**We thank Referee #3 for the time spent on reviewing the manuscript and providing constructive comments. We will work on the revised manuscript accordingly. Answers to the comments are given below.**

**General Referee Summary:** Shutter et al. report a miniaturized instrument for monitoring grade data for formaldehyde, HCHO, based on a mid-infrared laser / Herriot cell combination. They demonstrate performance sufficient for slow time response (15-60 min) HCHO in some outdoor and (likely) many indoor environments. They compare this instrument to state of the art, research grade LIF instruments with might higher precision, showing agreement to within 10% in the slope and  $\pm 0.5$  ppbv absolute difference for most conditions. They further demonstrate the utility of the instrument through a series of measurements at different locations on the Harvard campus in “personal monitoring mode”.

Figure S1 shows how the inlets are external to the portable Pelican case housing the sensor.

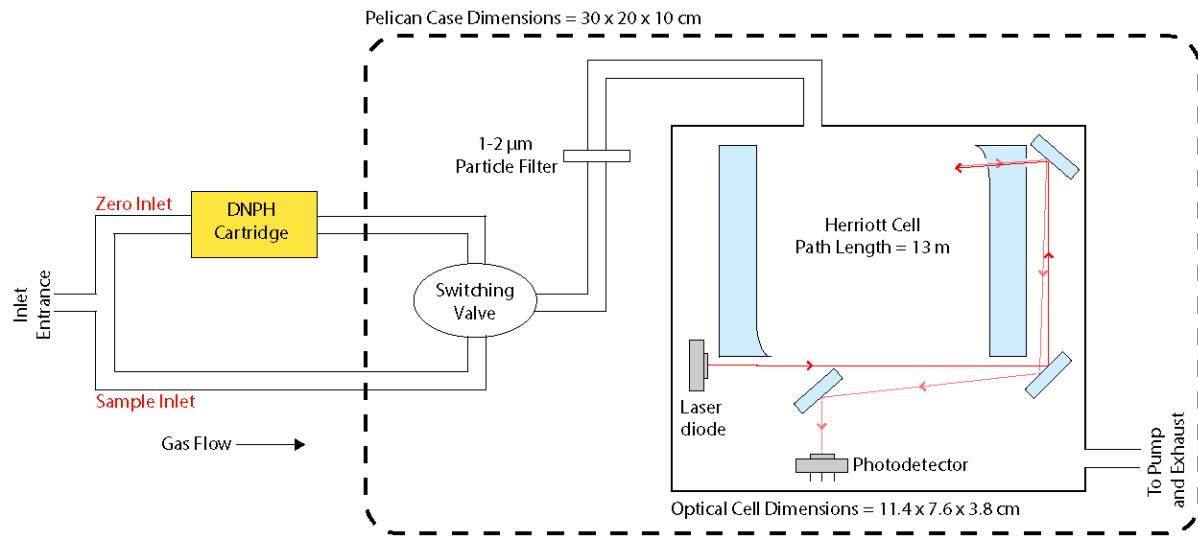
**Comment 7:** Page 3, Lines 10-11: Is the inlet system in figure 3 external to the package in Fig 1? This seems likely, and should be noted.

**Author Response:** The sample and zero inlets are indeed external to the package in Fig 1 and this is now duly noted in the manuscript and in the instrument schematic (Fig S1)

**Manuscript Changes:** “Using default settings, the three-way valve cycles between the two external inlets every 30 s”
